## **DELEGATED DECISIONS BY CABINET MEMBER FOR TRANSPORT MANAGEMENT**

### **SHIPTON-ON-CHERWELL - PROPOSED 20MPH SPEED LIMITS**

Report by Director of Environment and Highways

Drawing title  
 Sheet B

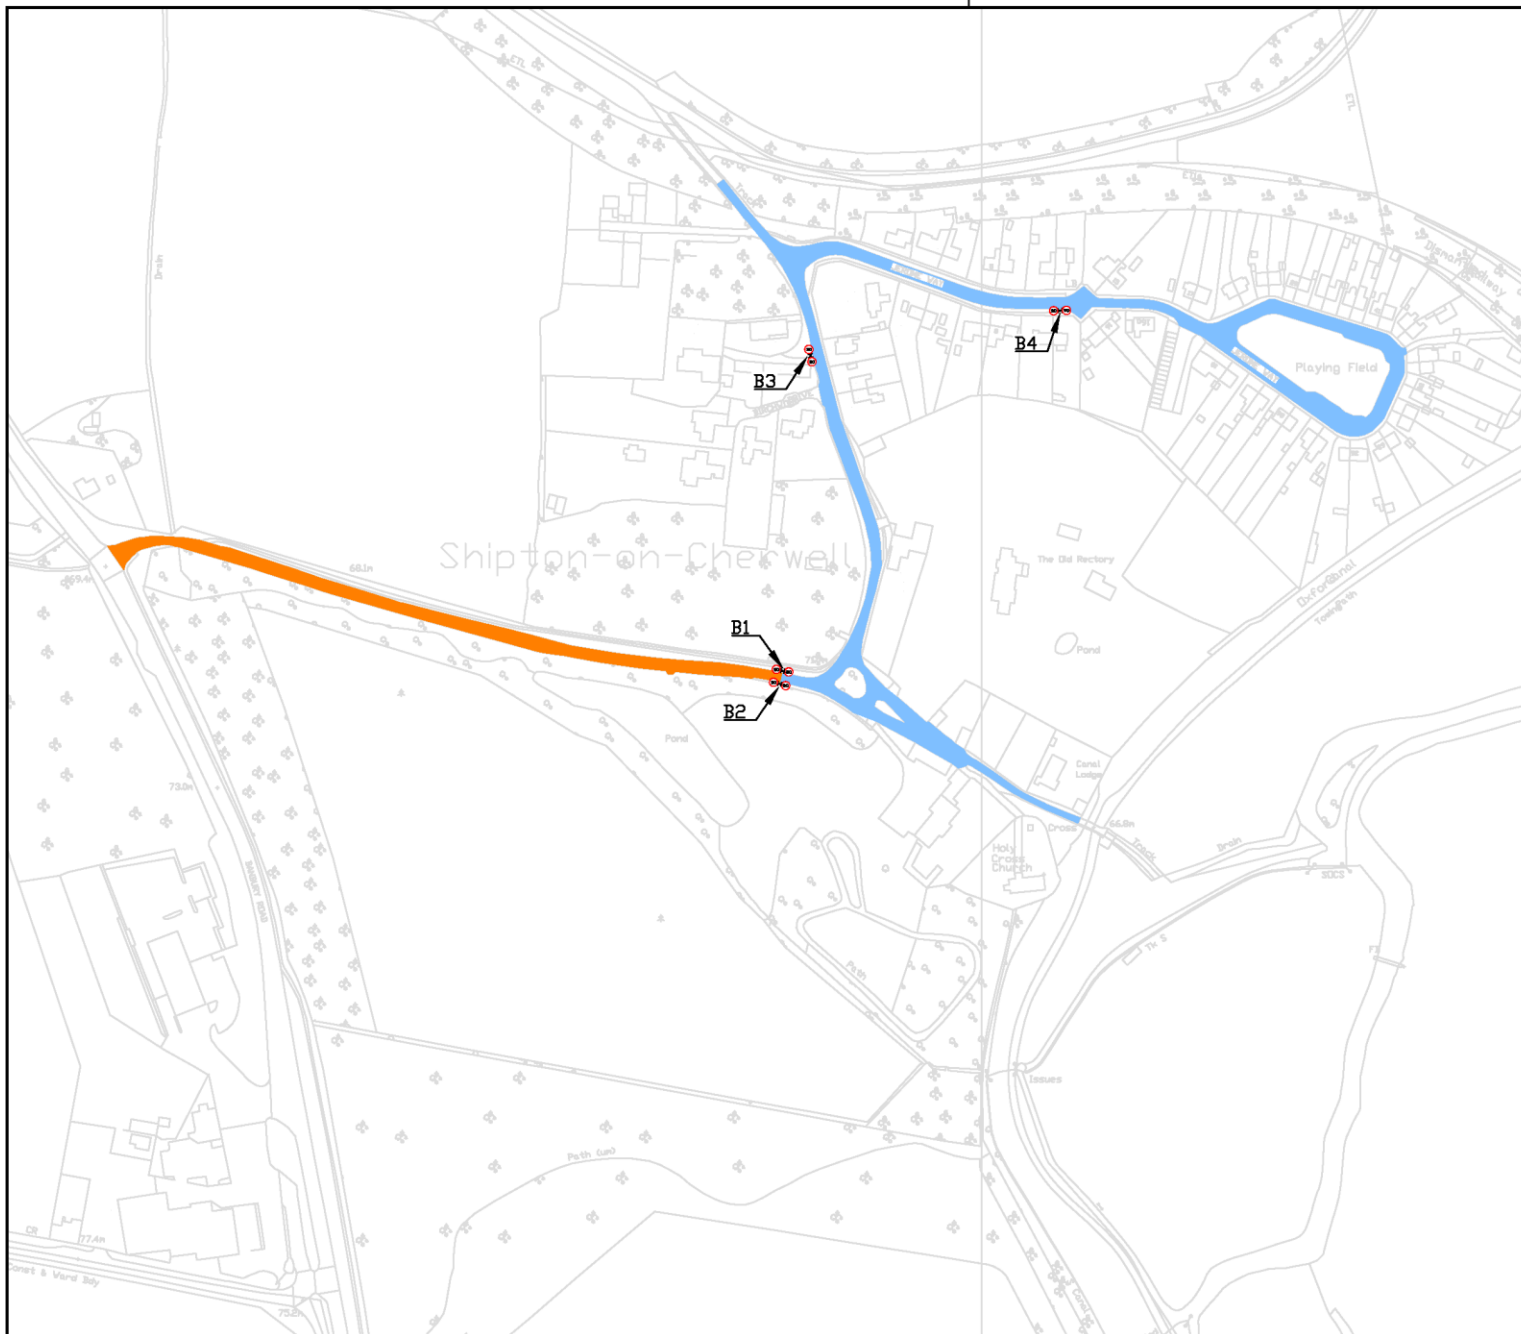
(3) Local resident, (Bunkers hill, Bunkers hill)	<p>20mph Shipton-on-Cherwell – <b>Object</b>  20mph A4095 Bunkers Hill – <b>Support</b></p> <p>Kids cross the road on a bilnd bend at bunkers hill to get to the school bus stop its dangerous</p> <p>Travel change: <b>No</b></p>

(4) Local resident, (Shipton on Cherwell, kidlington, Field view lane)	<p>20mph Shipton-on-Cherwell – <b>Partially support</b>  20mph A4095 Bunkers Hill – <b>Partially support</b></p> <p>20mph is way to low and is more likely to cause an accident as people tend to slow down dramatically as soon as they see a 20mph speed limit.</p>

12. The main purpose of the scheme is to encourage greater use of active travel by reducing speeds; this is also expected to reduce accidents. The aim of reducing speed limits is to change driver’s mindsets to make speeding socially unacceptable and make more environmentally friendly modes of travel such as walking and cycling more attractive – and also reduce the County’s carbon footprint. This forms part of a countywide programme of works that seeks to deliver ‘a safer place with a safer pace’.

Drawing title  
**Sheet A**

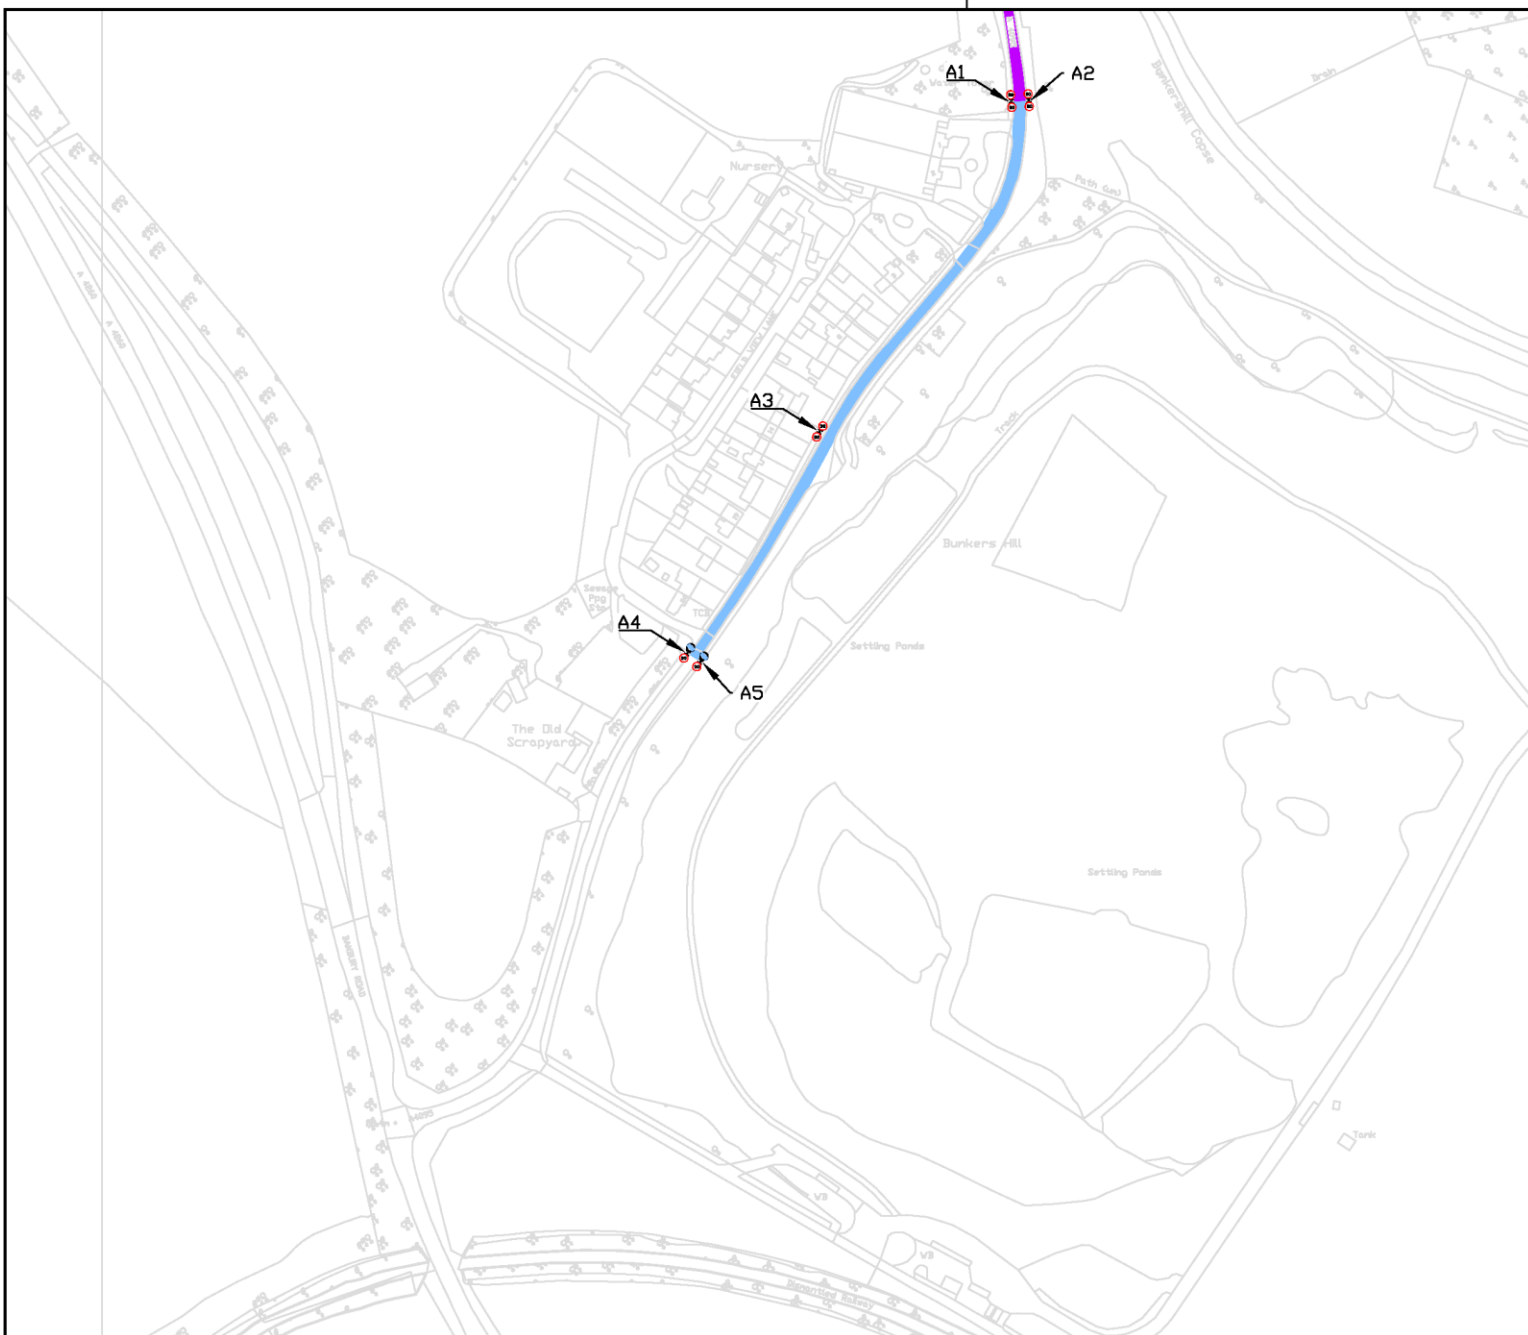
- Thames Valley Police re-iterated their views concerning OCC's policy and practice regarding 20mph speed limits and wish their response to be listed as 'having concerns' rather than an objection. They also queried why the short section of the A4095 from the A4260 towards the proposed new 20mph speed limit was remaining at 60mph National speed limit, thinking that reducing that to 50mph also was more appropriate.
- Oxford Bus Company offered no objection, citing that the proposals would have no impact on regular bus services.

RESPONDENT	COMMENTS
<p>(1) Traffic Management Officer, (Thames Valley Police)</p>	<p><b>Concerns</b> – In addition to my Standard response. I'm slightly puzzled by the A4095 proposal for Bunkers Hill. Forgive me for suggesting a lower speed limit !! I find it strange the short section of the A4095 from the A4260 to new 20 is to remain at National. Would it not be more in line to drop it to 50.</p> <p>Thames Valley Police welcome the opportunity to engage on plans for road safety improvement and acknowledge that 20mph limits can be a useful tool in road safety. There are other reasons 20mph limits may be desirable for communities, such as environmental concerns, and creating a shared space environment to encourage greater diversity of road users.</p> <p>Compliance with 20mph limits is a challenging issue as there is a difference between the achievable results of the various available schemes. For example a sign-only scheme will only have a limited effect on the mean speeds, as opposed to other schemes that influence the road environment, which is recognised as being key to achieving compliance. If a speed limit is set too low and is ignored then this could result in the vulnerable road user being less safe. It can also cause a disproportionate number of drivers to criminalise themselves and could bring the system of speed limits into disrepute.</p> <p>Thames Valley Police have no policy to enforce based on arbitrary speed limits alone but will enforce based on threat of harm, risk and resourcing. 20mph limits are not excluded from this and will be enforced where appropriate. There should be no expectation that the police would be able to provide regular enforcement if a speed limit is set too low as this could result in an unreasonable additional demand on police resources and there are no additional resources available to support extra enforcement. Messages from partners that police will not enforce need to be discouraged. Such messaging can encourage non-compliance and should be avoided.</p> <p>The policy of Thames Valley Police is to use sound practical and realistic criteria (Setting local speed limits - GOV.UK (<a href="http://www.gov.uk">www.gov.uk</a>)) when responding to Highway Authorities in an effort to promote consistency and to reduce the burden of constant and unnecessary enforcement. The advice shown in Circular Roads 1/2013 states.</p> <p>The key factors that should be taken into account in any decisions on local speed limits are:</p> <ul style="list-style-type: none"> <li>• history of collisions</li> <li>• road geometry and engineering</li> <li>• road function</li> </ul>

13. The concerns of Thames Valley Police primarily comprise observations applicable to the overall 20mph project; their suggestion for replacing the current length of national speed limit on the A4095 between the A4260 and the proposed 20mph speed limit at Bunkers Hill (given that the A4260 itself is already 50mph) will be followed up separately as part of a current review of the speed limits on the A4260 under the Vision Zero speed management programme. A 30mph or 40mph speed limit reduction on this length was also requested by members of the public expressing partial support for this proposal.
